Steel Framed Building
at
Rotherham, S63 9BL
for
Hanson Buildings Limited

Front and Back Elevations

SCN3068 06 B

Back Elevation

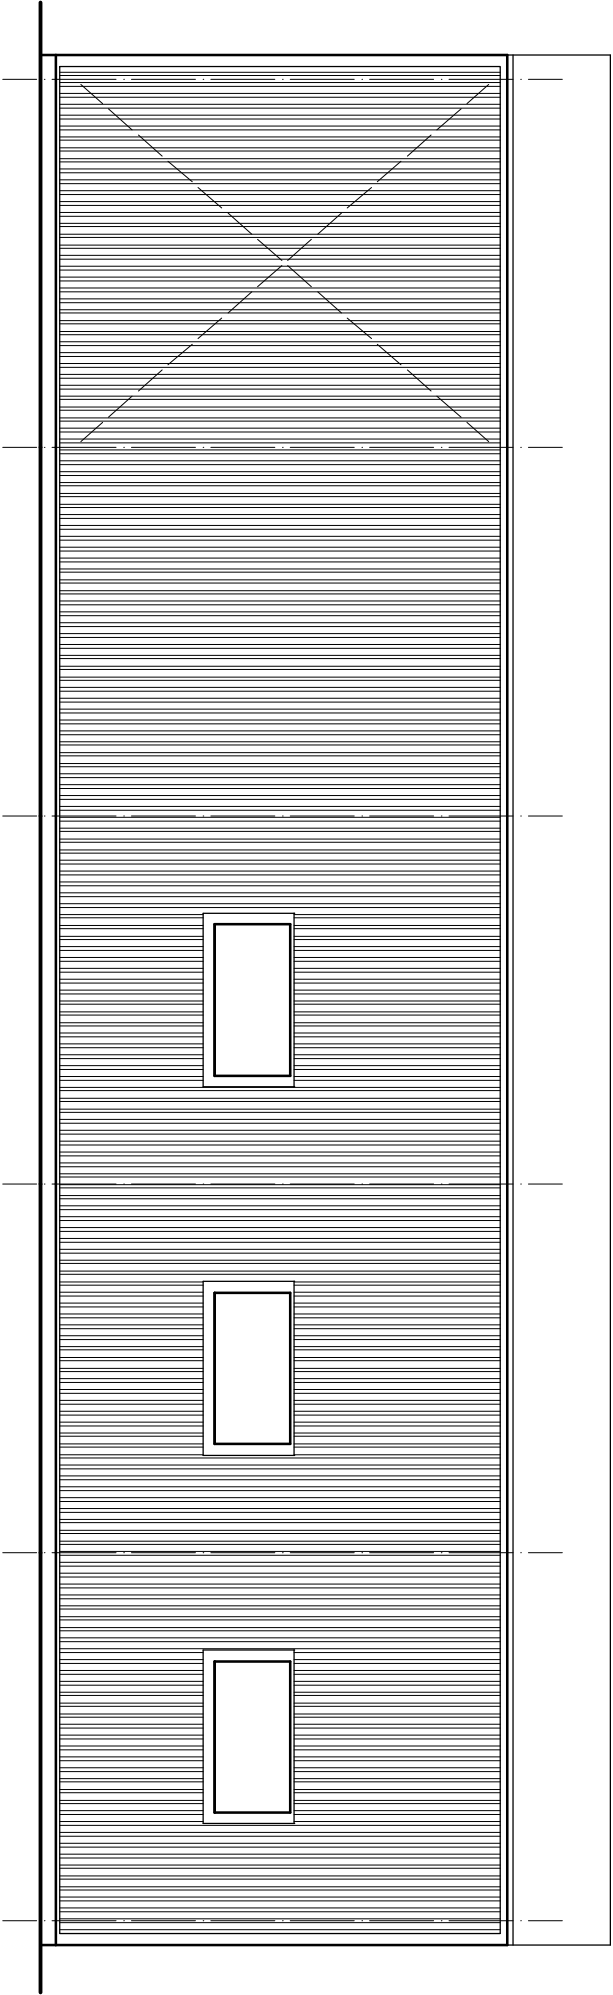
Rev B Revised to add windows and windpost frame to rear elevation. 02/07/26

Front Elevation

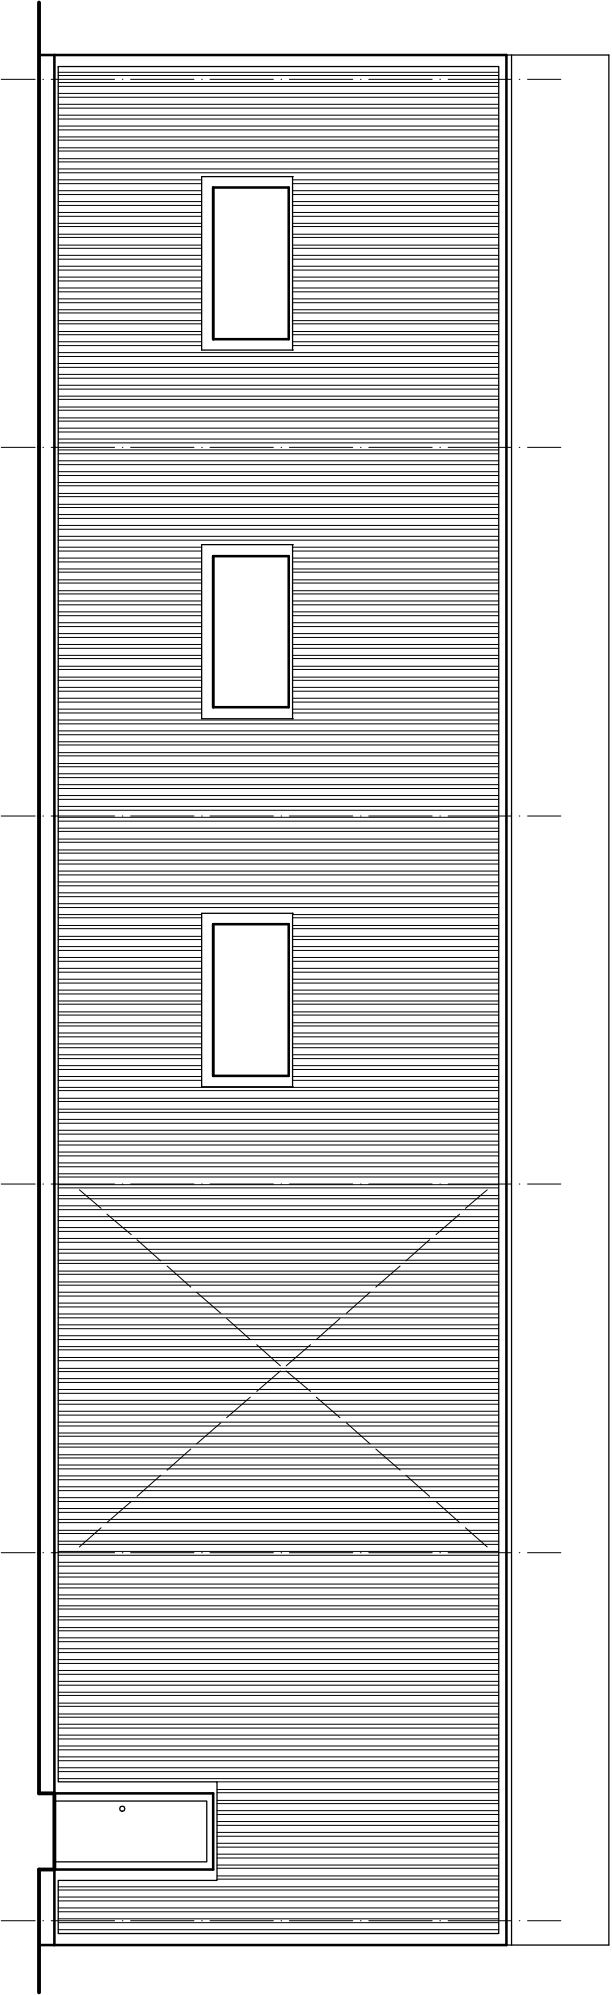
Rev A Revised building design and door locations. Also Windows and windpost added. 28/04/26
